From: David Mahoney <DavidMahoney@tjthomas.co.uk>
Sent: 23 July 2021 15:02
To: Quinn, Mark
Subject: RE: External Mail: Queens Arms - Planning application 21/00062/FUL
Attachments: queens arms-1.pdf

THE QUEENS ARMS
39 BLACKLOW BROW
HUYTON
PROPOSED FIRST FLOOR PLAN

THE QUEENS ARMS
39 BLACKLOW BROW
HUYTON
PROPOSED ELEVATIONS
 1:100 SCALE DWG NO. QA/08 JAN 21

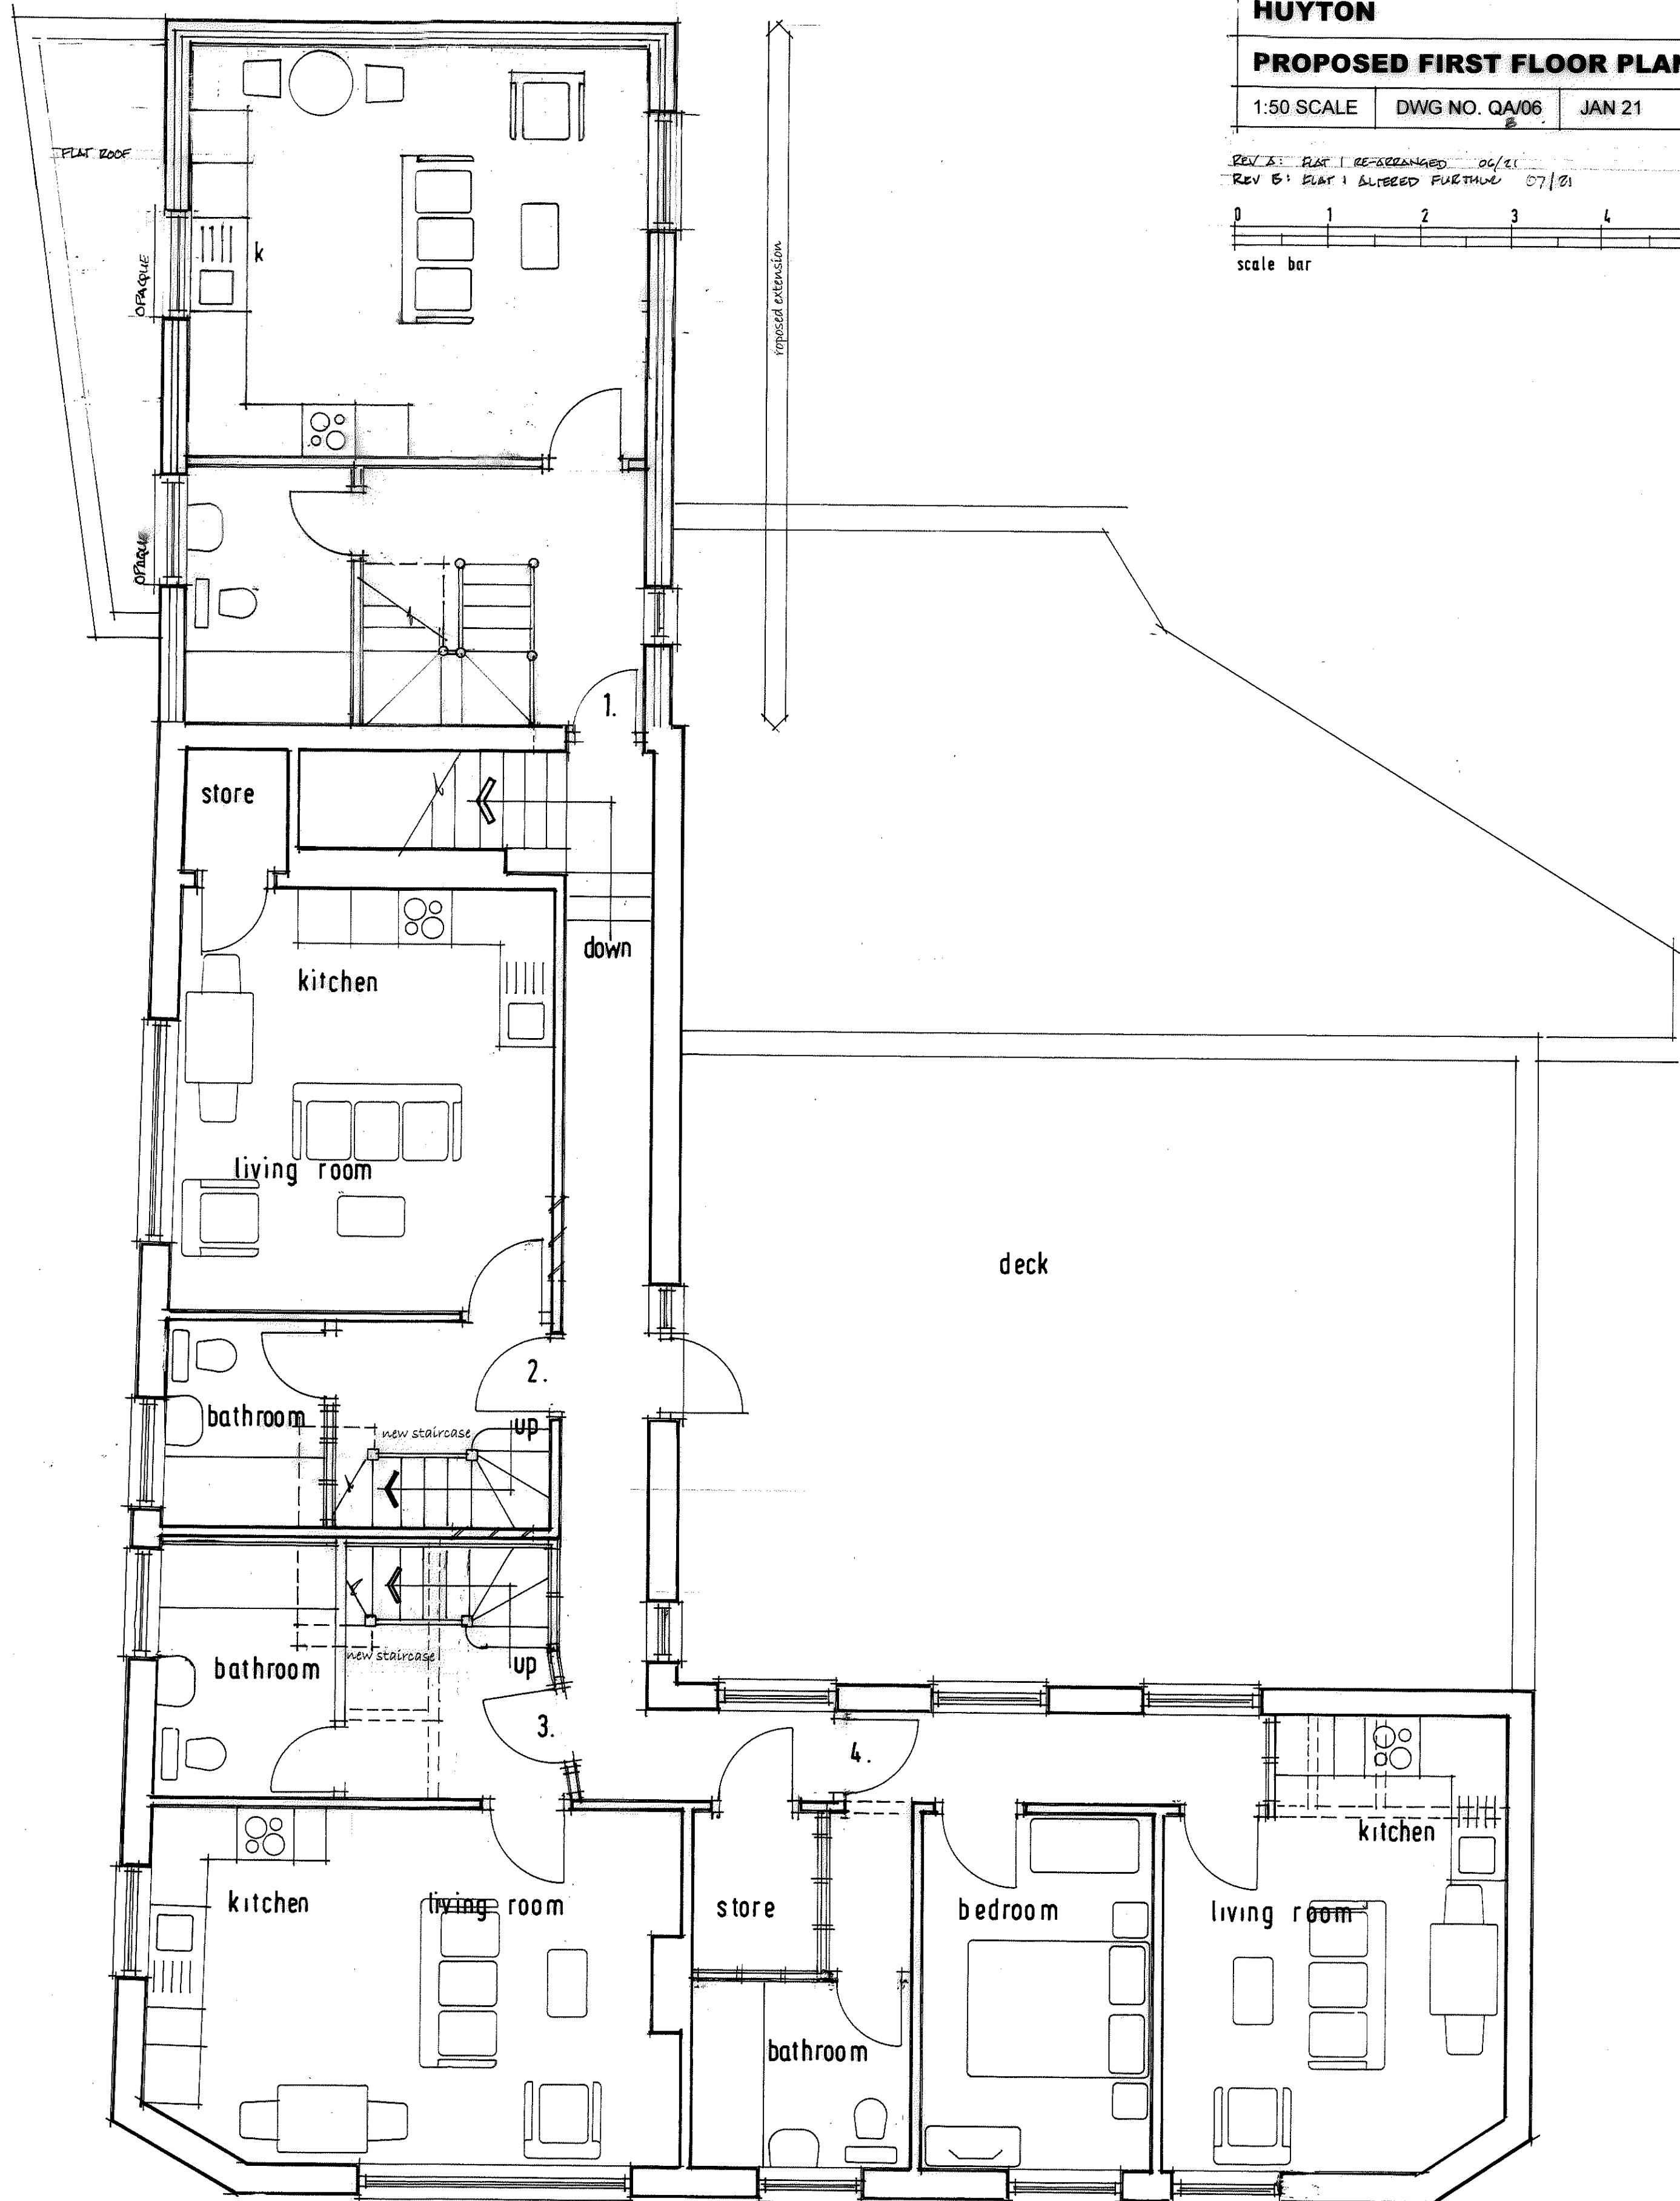
I have discussed this further with my manager and whilst we welcome the removal of the balcony there are still main habitable room windows facing the front elevation of 1 Pinnington Place which also has habitable room windows at a distance of approximately 11m. Given the minimum distance is 22m unfortunately we are unable to support this.

As previously suggested we would recommend looking at ways to re-configure this apartment so only bathroom or obscurely glazed windows to allow additional light are positioned on the elevation facing Pinnington Place. Possible solutions include removing the corridor and making the apartment more open plan. Reposition windows to the rear elevation/other side elevation facing the beer garden.

To deal with the issue of overlook ,I have altered the new flat 1 to a duplex, with the upper floor rooflight to the rear.

REV A: PLAN 1 RE-ARRANGED 06/21
 REV B: PLAN 1 ALTERED FURTHER 07/21
